Comments to the author:

Review #1

Review #2

“Towards ice thickness inversion: an evaluation of global DEMs by ICESat-2 in the glacierized Tibetan Plateau” by Wenfeng Chen et al.

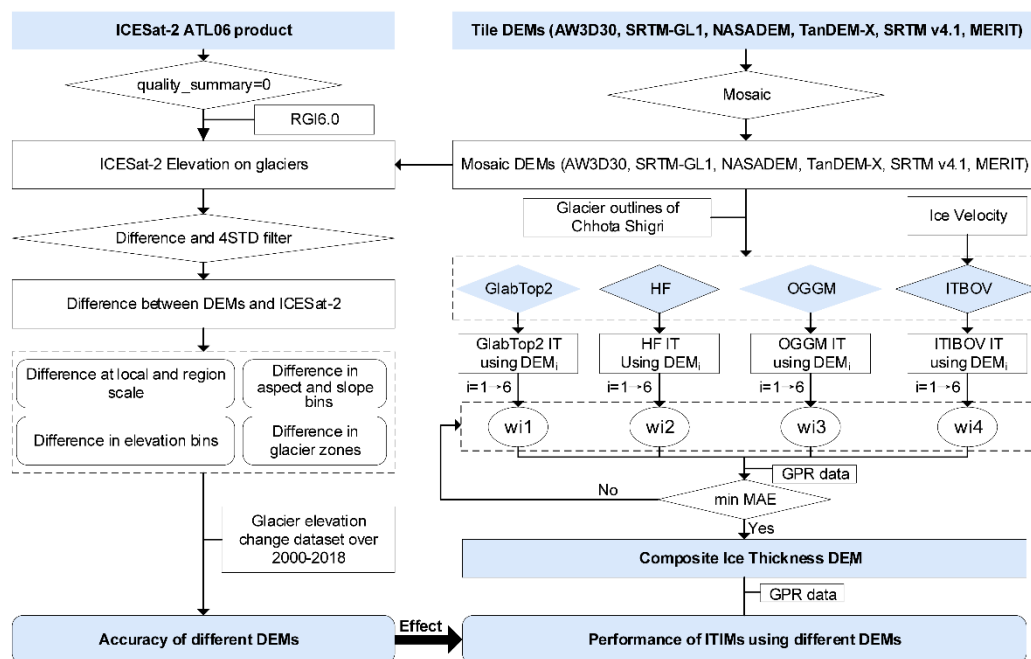
16. Figure 2: “Difference in aspect and slope bins”.

17. Figure 2: Make different blue boxes into just blue color.

Response: Corrected.

Response: Corrected.

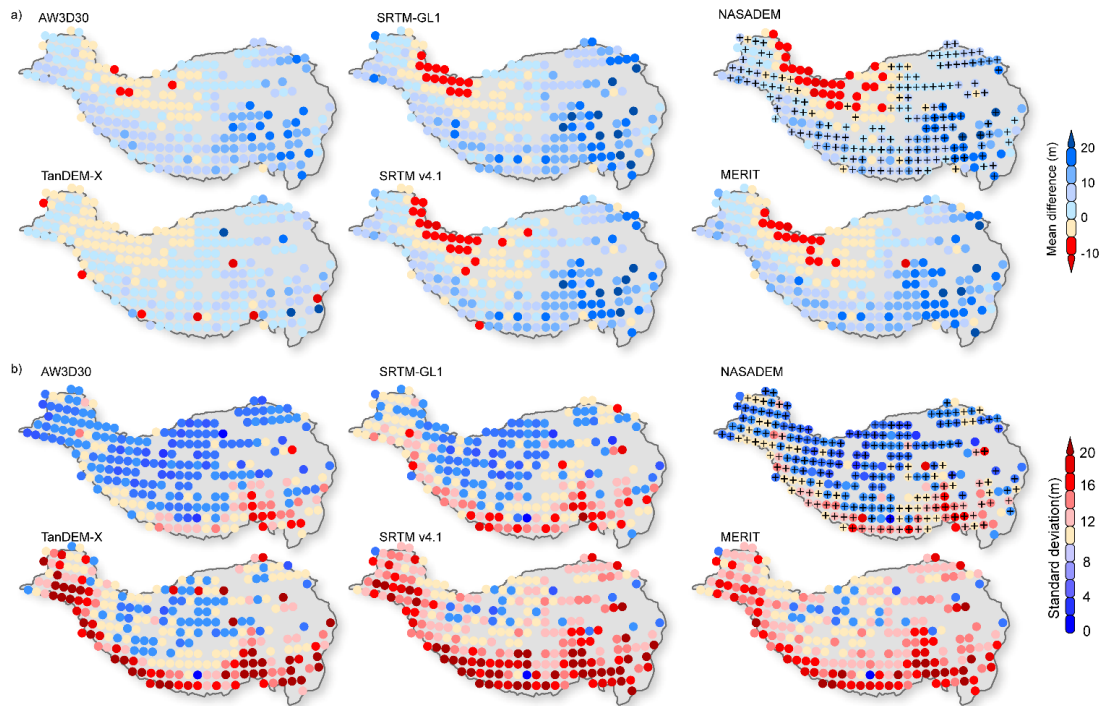
24. Figure 3 & Figure 4: Why would RMSE in both figures be different? For example, for AW3D30 it is 13.4 m in Fig 3, but it is 34.9 m in Fig 4. Please make sure the data are consistent throughout the paper.

Response: The RMSE in Figure 3 and Figure 4 are different. ‘R2’, ‘RMSE’ and ‘Intercept’ are fit results when the slope coefficient is set to 1. In fact, the RMSE in Figure 3 should be equal to the STD in Figure 4. The intercept should be equal to the ME in Figure 4.
